We, Shenzhen Intellirocks Tech. Co., Ltd., hereby apply for Class II permissive change to the approved product under FCC ID: 2AQA6-H6008, date of original grant: 08/11/2021.

There are three changes, as follows:

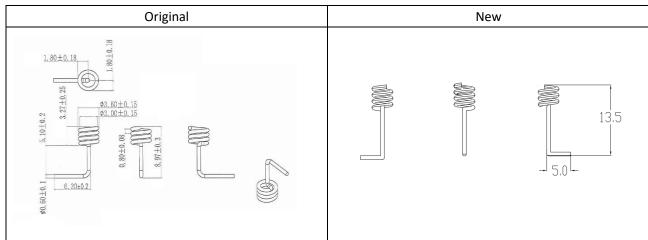
2. An aluminum cooling device was added to the original metal structure

Antenna Dimension

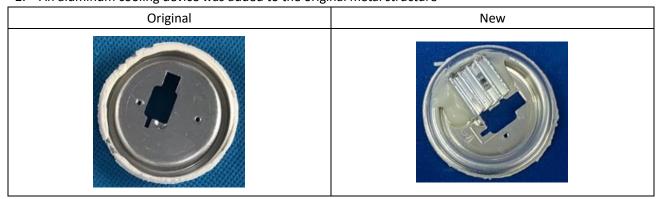
1. The antenna has been modified.

In the RF circuit section, there are no modifications except for the replacement of the antenna. In addition, there are no modifications to the motherboard circuit.

Ant.	Туре	Operation Frequencies (MHz)	Gain (dBi)	Manufacturer
Original	Spring	2400~2500	1.5	Shenzhen Qianyan
New	Spring	2400~2500	-0.41	Technology LTD

Note Φ = 0.6, Unit: mm
